SERVICE BULLETINNO. 9DATE 11.6.90CFM METAL-FAX LTD CONSIDERS

SUBJECT SUPPORT FOR FRONT HANGER BRACKET.

MODELS AFFECTED SHADOW SERIES B, B-D, C, C-D,  
STREAK SHADOW SERIES S-A1, S-A

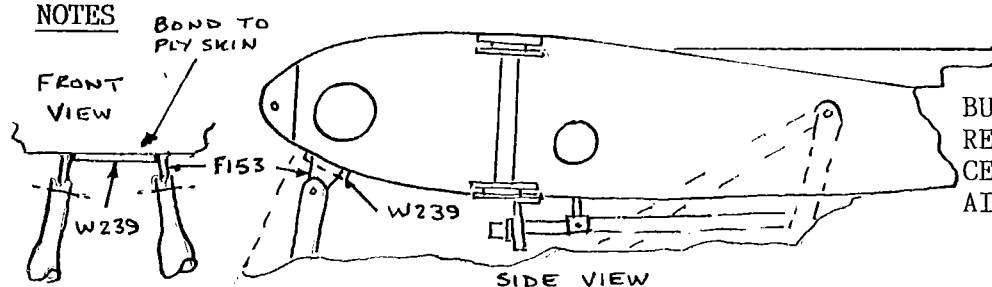
TO GIVE SUPPORT TO PLY 'D' SKIN PANELLING BETWEEN HANGER TUBE BRACKETS (FRONT).

SLIGHT OVER-STRESSING OF THE 'D' BOX PLY SKIN AROUND BRACKETS (F153) IS POSSIBLE IF THE AIRCRAFT IS ABUSED IN THE AIR, e.g. SIDE SLIPPING.

FIT PLYWOOD PART No. W239 AS A PUSH-FIT BETWEEN HANGER TUBE BRACKETS (PART No. F153). REMOVE AND BOND BACK IN PLACE WITH ARALDITE QUICK-SET EPOXY. (IT IS NOT NECESSARY TO REMOVE PAINT FROM 'D' SKIN BEFORE BONDING, IF THE FIT IS TIGHT).

W239 - PAD, ARALDITE - QUICK-SET 5 MIN EPOXY.
